Addendum No. C

To the contract documents for NORTH VERDEMONT ELEMENTARY SCHOOL, DSA No. 04-122168

For the SAN BERNARDINO CITY SCHOOL DISTRICT

LPA Project No.: 30899

L5.01

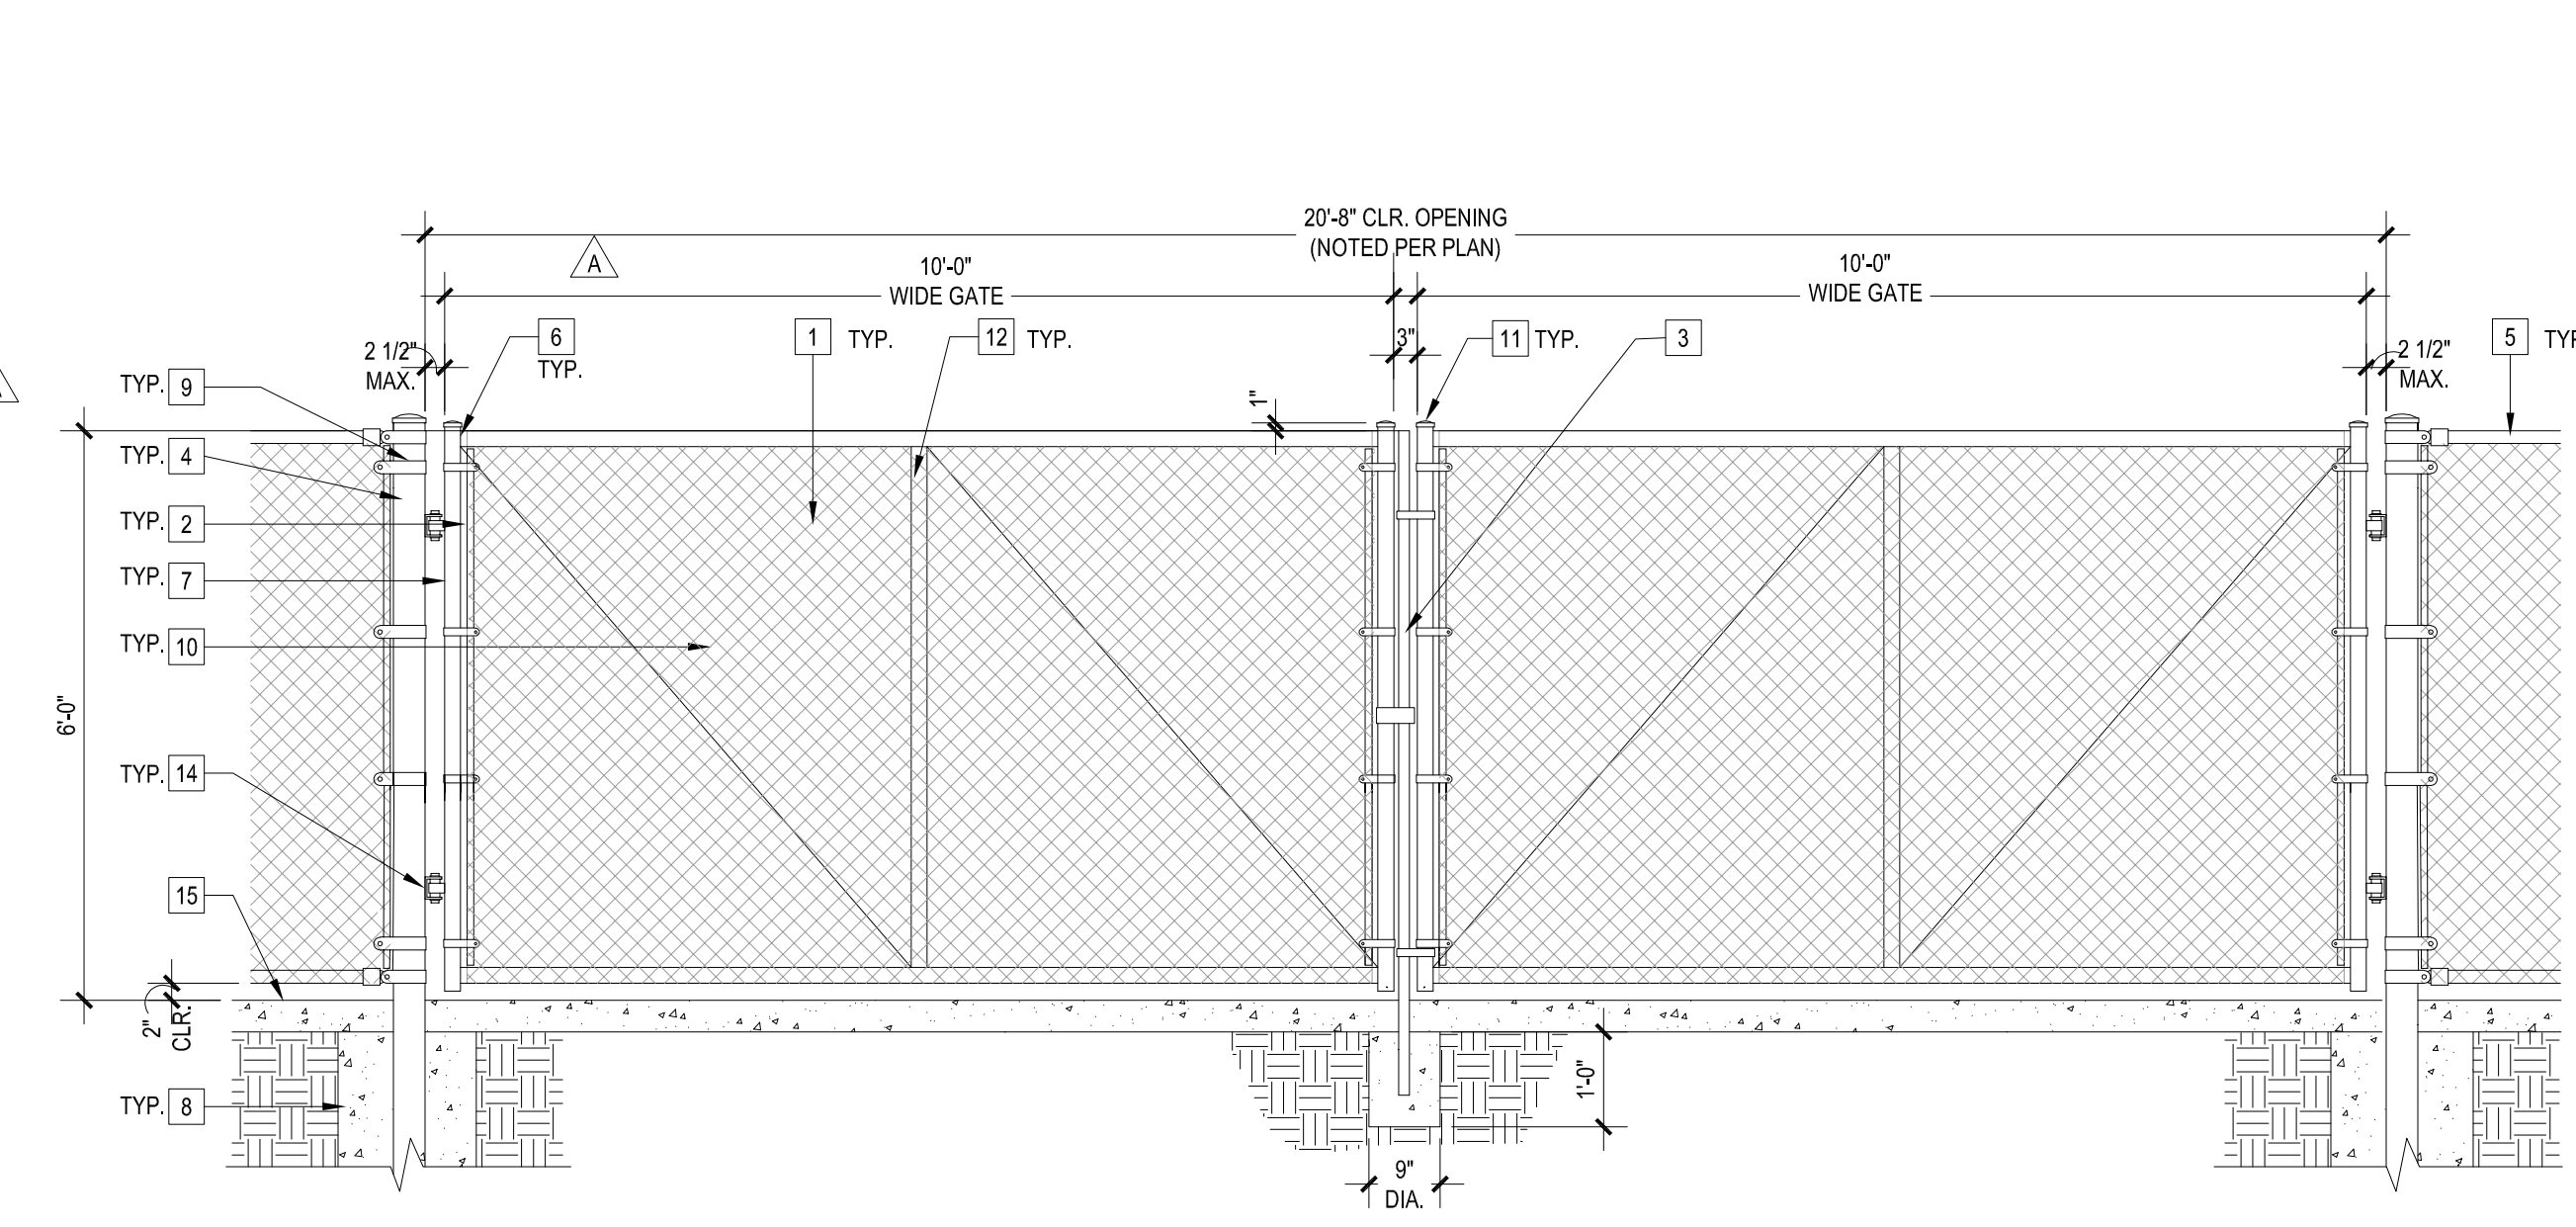
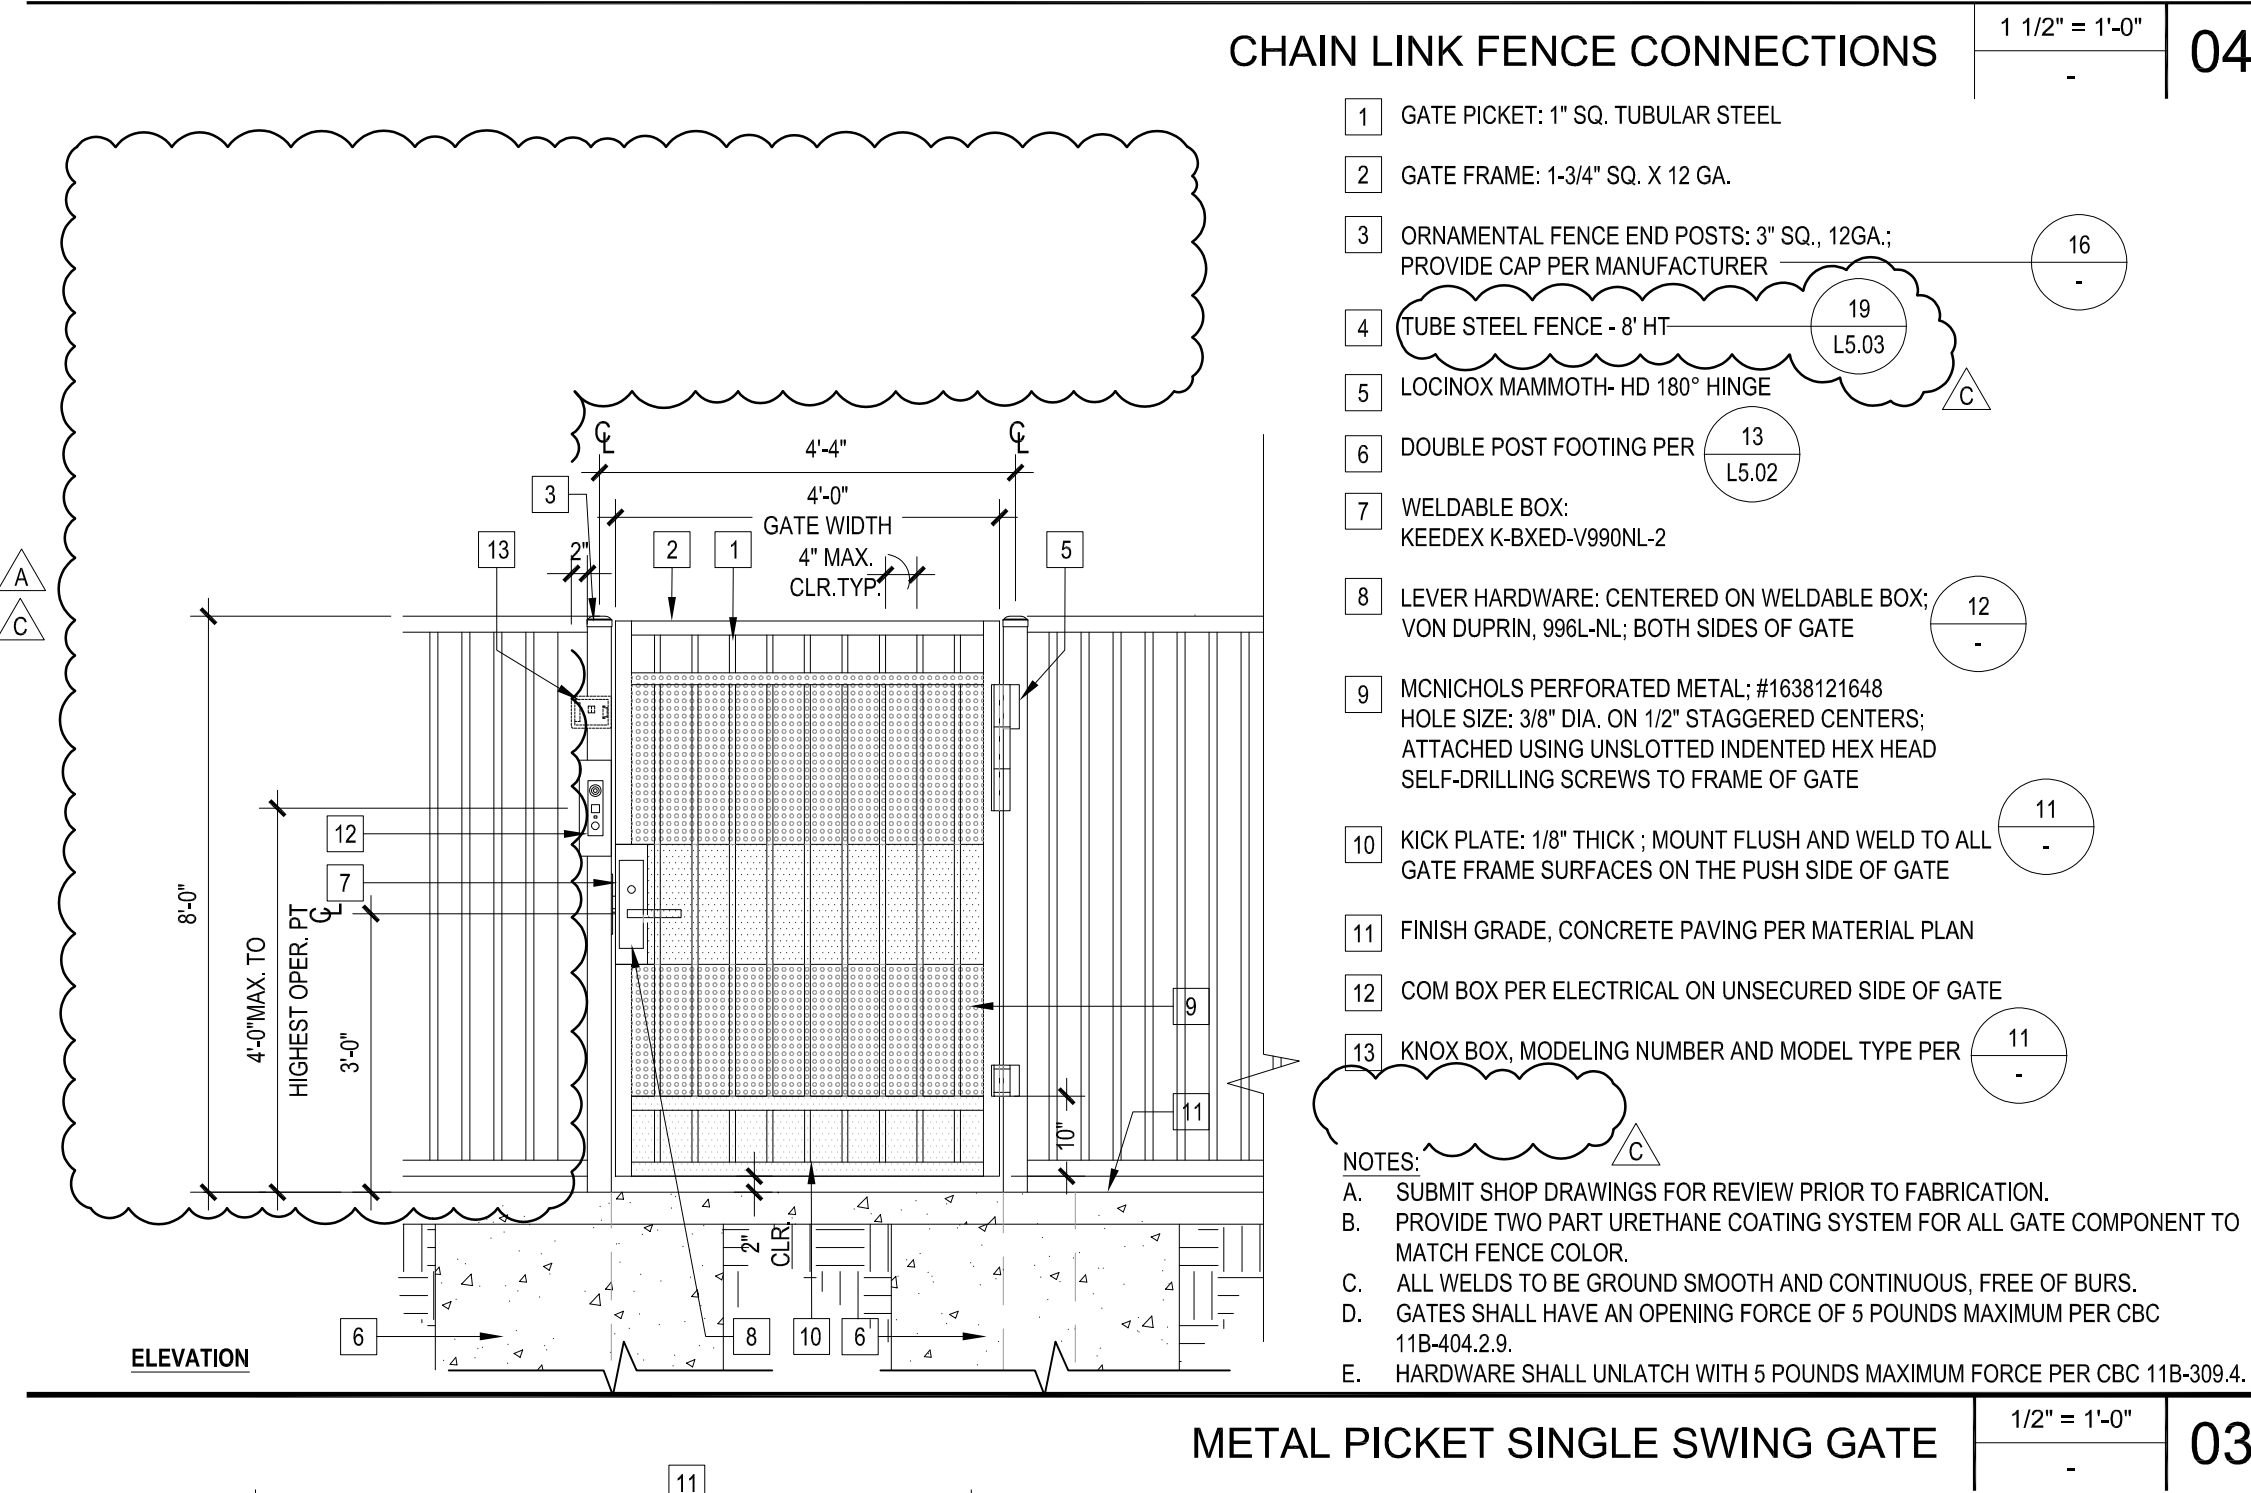
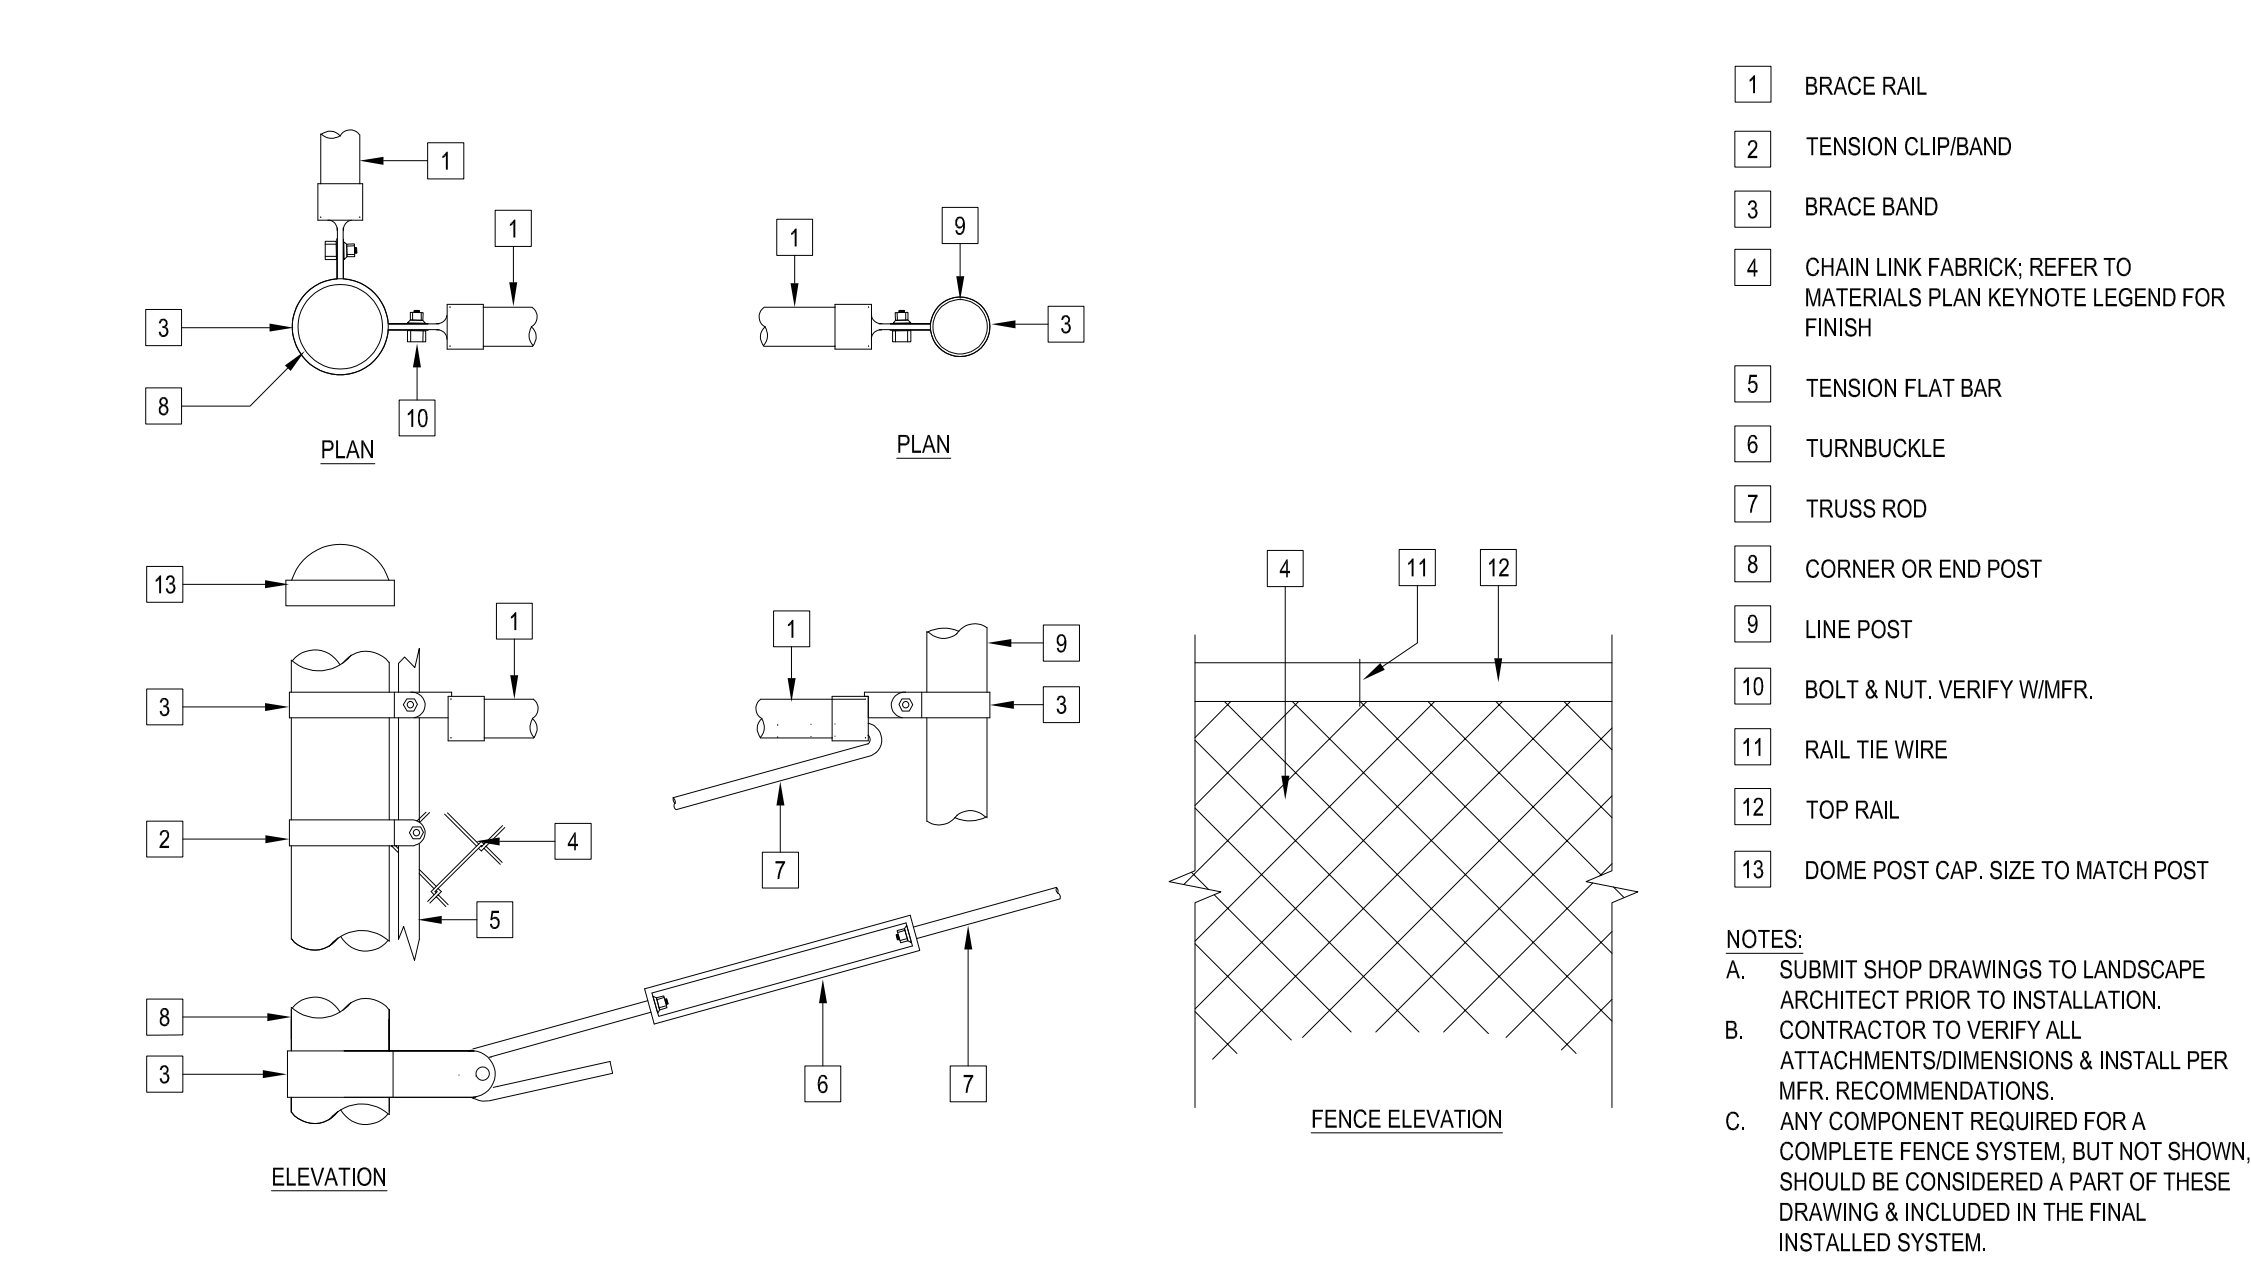
- Item No. 16**      L5.01 – Construction Details
  - a) Revised depth of DG.
- Item No. 17**      L5.02 – Construction Details
  - a) Added bike rack detail.

- Item No. 5** Per sheet L5.01 detail 16 it states DG to be 3" thick. Per Installation of DG Mix 3.06C it states thickness to be 4". Please clarify what depth is to be used.

- Item No. 8** Detail 16/L5.01 does not shows aggregate base under decomposed granite. However, specs 321500/3.05 shows to install aggregate base. Please clarify if aggregate shall be installed under DG. If yes, please provide depth to install base.

- Response: No aggregate base beneath decomposed granite.
- Item No. 9** Detail 16/L5.01 shows 3" depth of decomposed granite. However, specs 321500/3.06 shows 4" depth. Please clarify.

Response: Use 4" per specifications.

- Response: Use 4" per specifications.
- Item No. 10** Irrigation material legend/ L6.02 shows sleeves shall be installed 24" depth under pedestrian paving & 36" depth under vehicular paving. However, detail O/L6.04 shows lateral line sleeves are installed 12" depth under pedestrian paving & 24" depth under vehicular paving. Please clarify.
